Planning Commission

Planning Commission Meeting Agenda
Hartland Township Hall
Thursday, June 12, 2025
7:00 PM

Hartland Township Planning Commission Meeting Agenda Memorandum

Subject: Site Plan/PD Application #25-004, Sawyer Ridge, Residential Planned Development (PD) – Preliminary Site Plan

TYPICAL LOT DATA

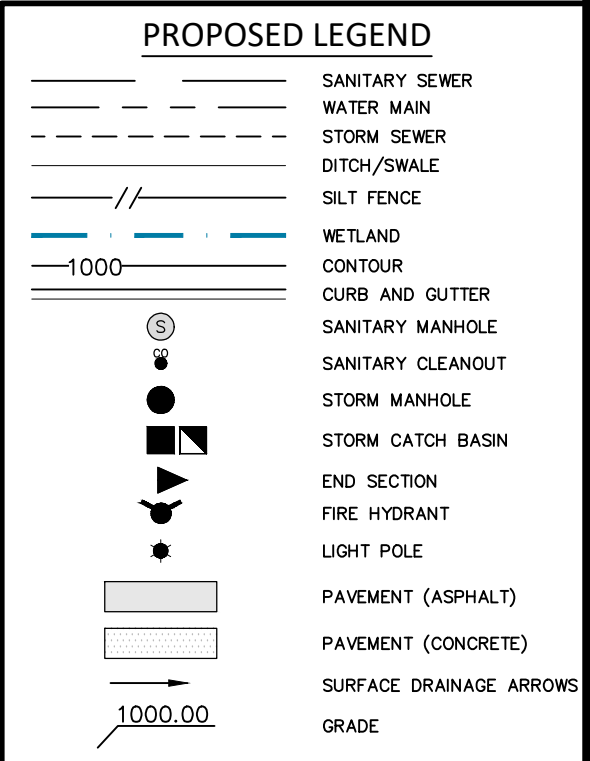
Sheet C8 of the site plans shows a drawing of a typical 60-foot-wide by 120-foot-deep lot with setbacks that define the building envelope (Typical Lot Data). The setbacks are noted below.

Lot coverage. Lot coverage is not stated on the plans. All structures and site elements are to be built within the building envelope with the exception of driveways and sidewalks (from house to street). Site elements include hard surfacing (concrete patios, paver patios, sidewalks, pool apron), deck, shed, pools, pavilion, gazebo, and other built structures.

PAGE No.:
C18

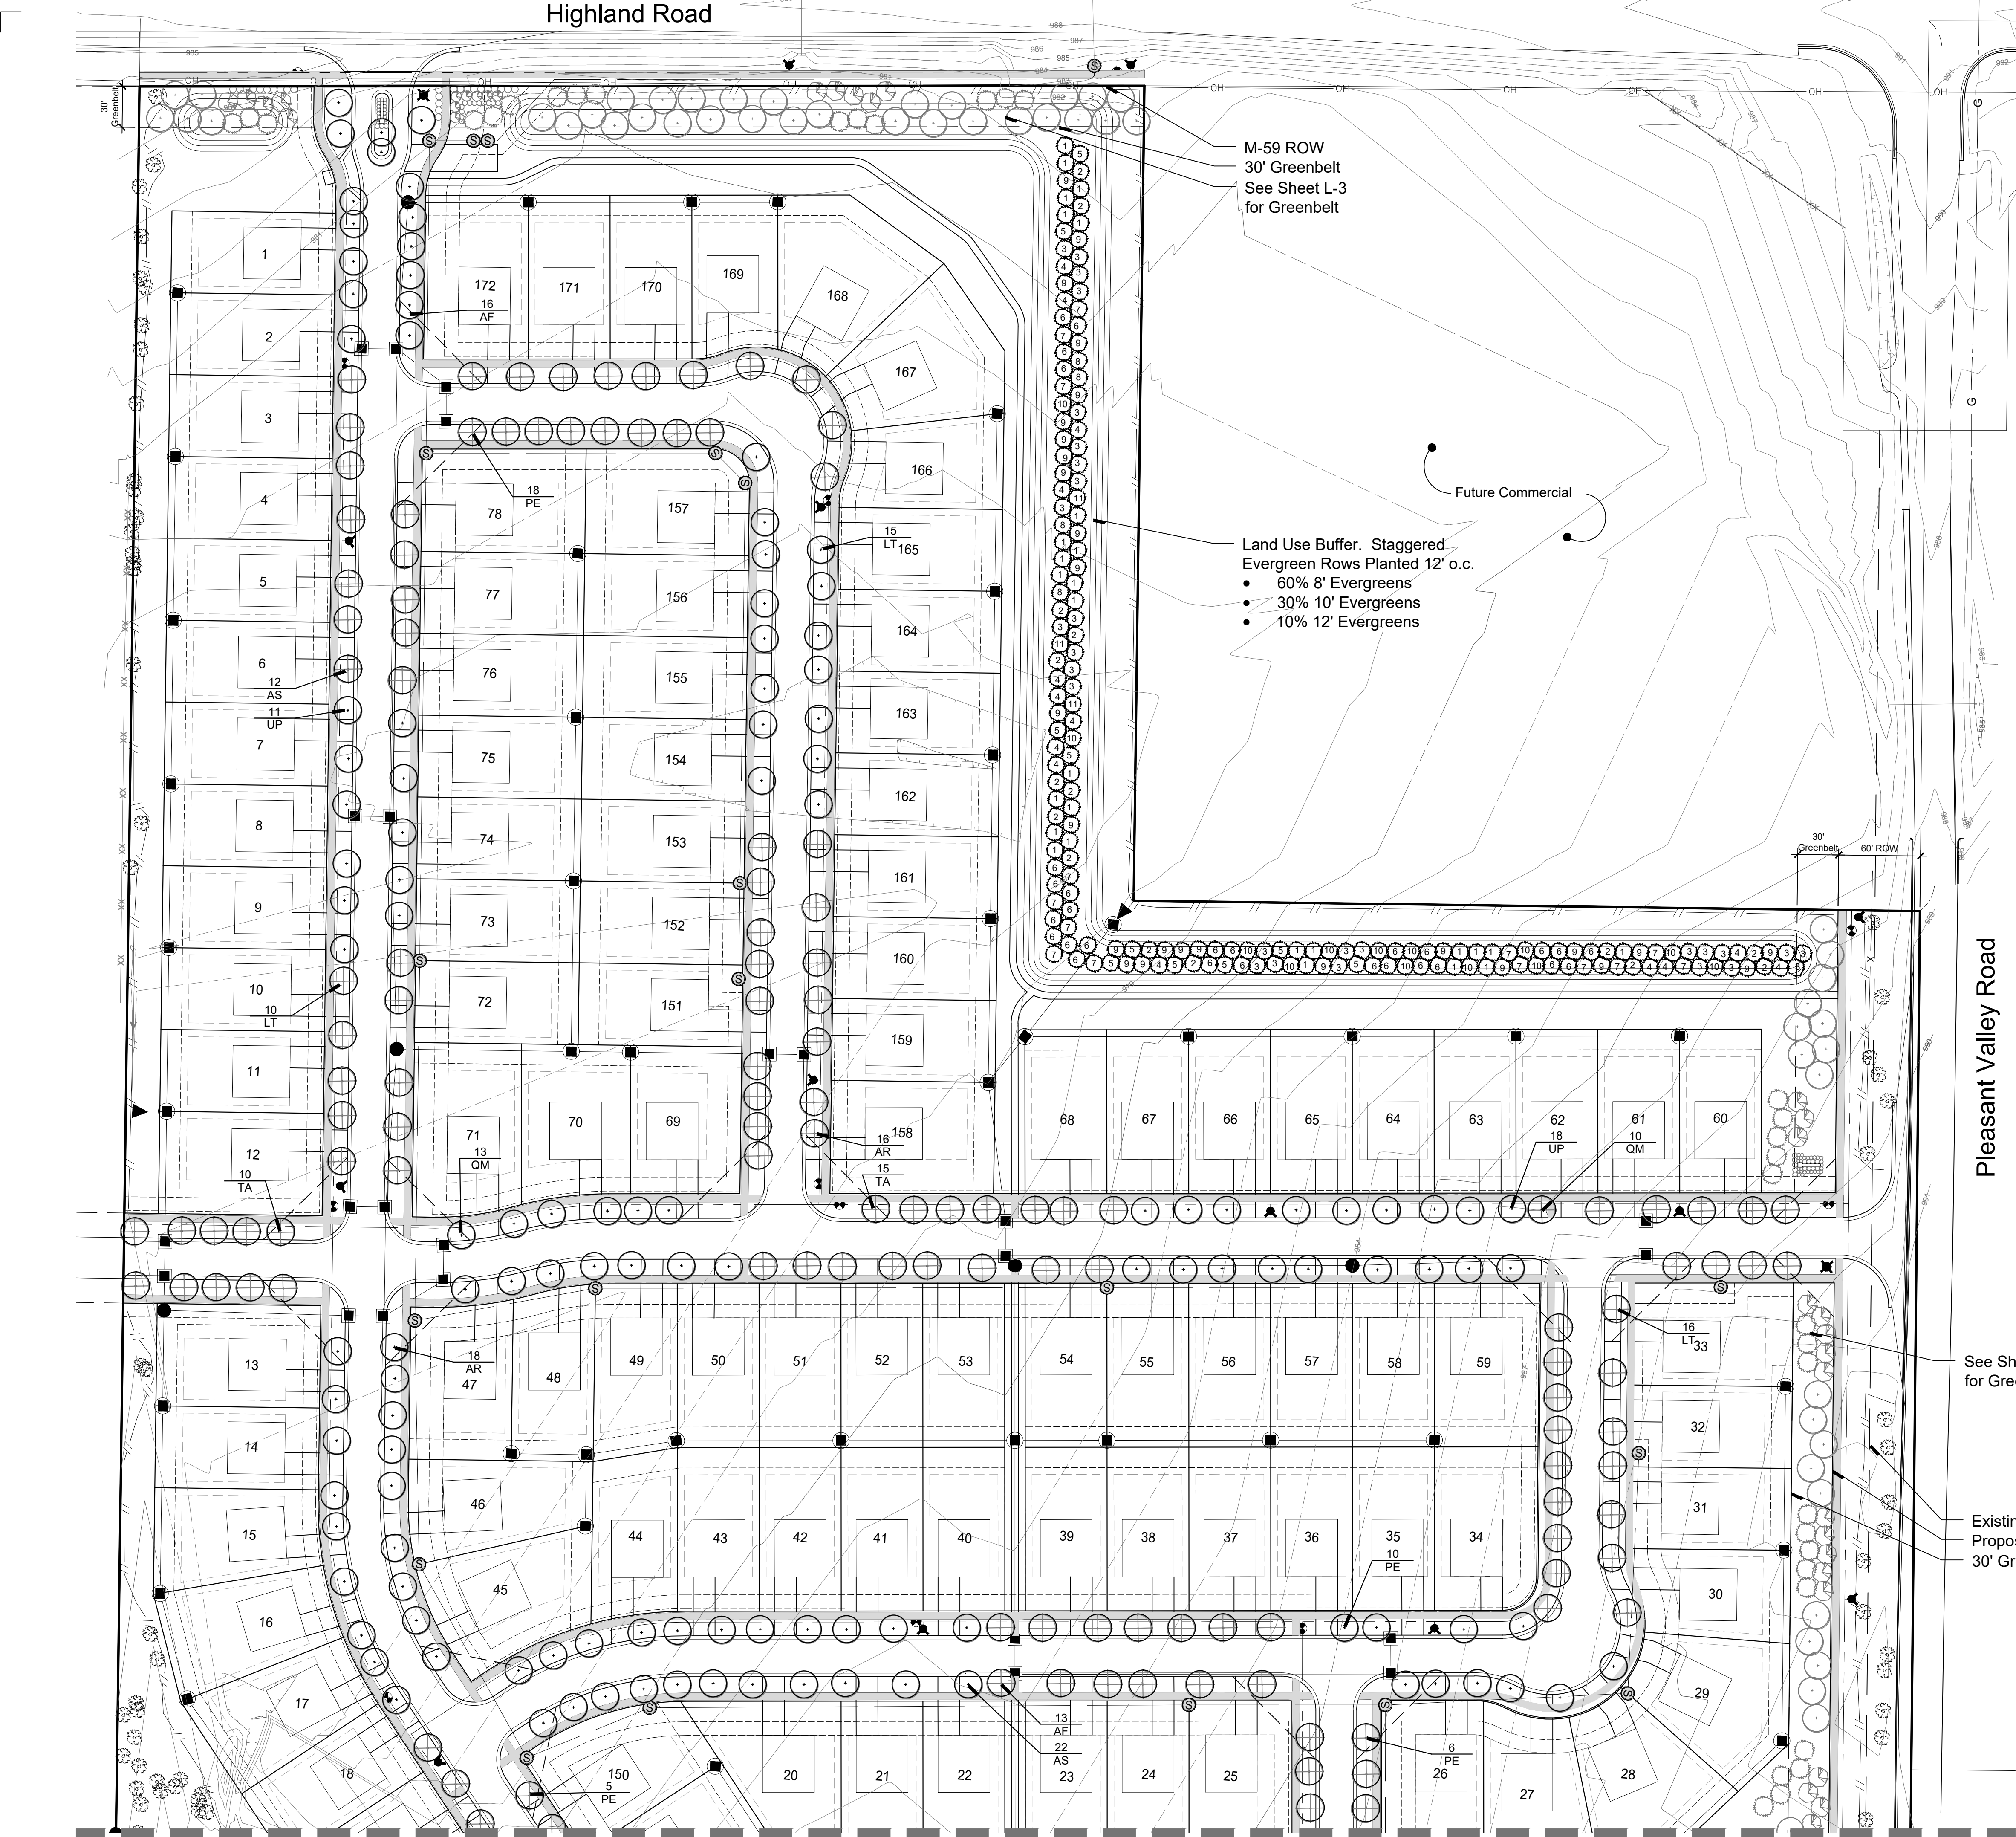
Street lighting is proposed and detailed information for the light fixture is found on Sheet C18. Information on the pole height and pole color are not provided. Sheet C18 states ten (10) streetlights are proposed; however, the site plans do not show the streetlight locations. An elevation drawing of the pole and luminaire, with the total height stated (light fixture and pole) should be included in the Construction Plan set, as well as a plan showing the streetlight locations.
